CERTIFICATE OF APPROPRIATENESS PLACARD

731 S BOYLAN AVENUE

090-14-MW

- Remove and replace front and side doors.

DIAMONDBACK COLLECTION

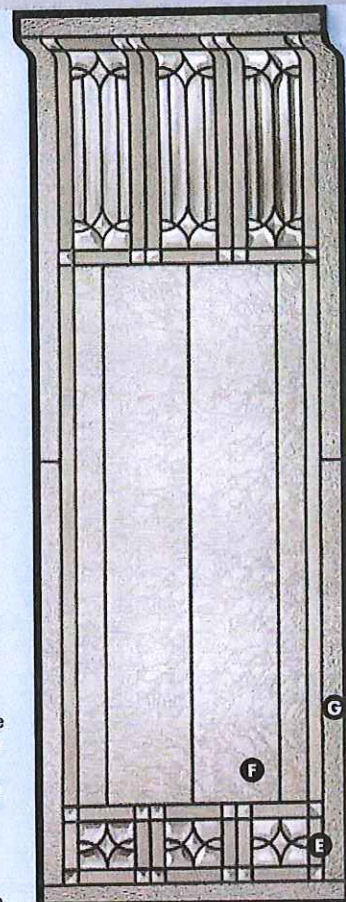
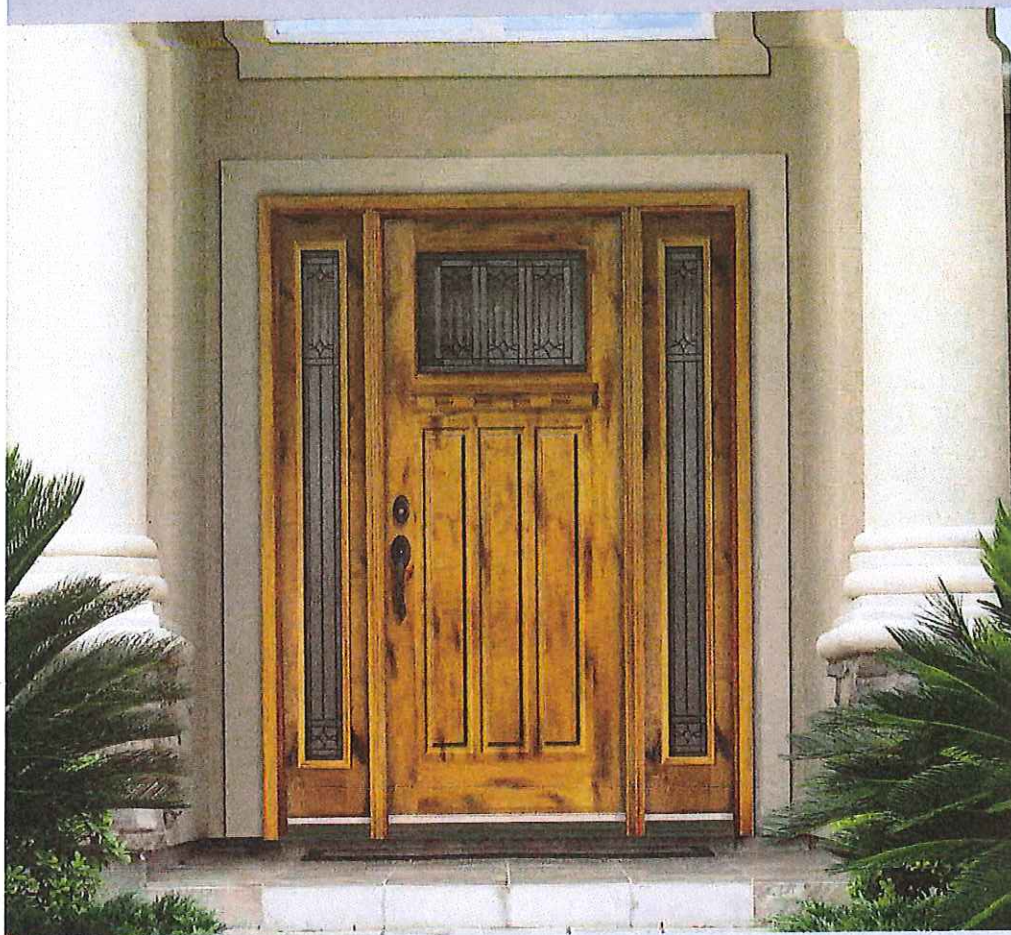
Tania—I've selected a new Oak front door and have attached info for it (both specs & a picture) as well as the rear deck door (which is smooth fiberglass). I will also send another email with pictures of the current doors (I don't want to load too many files). Thanks, Victor
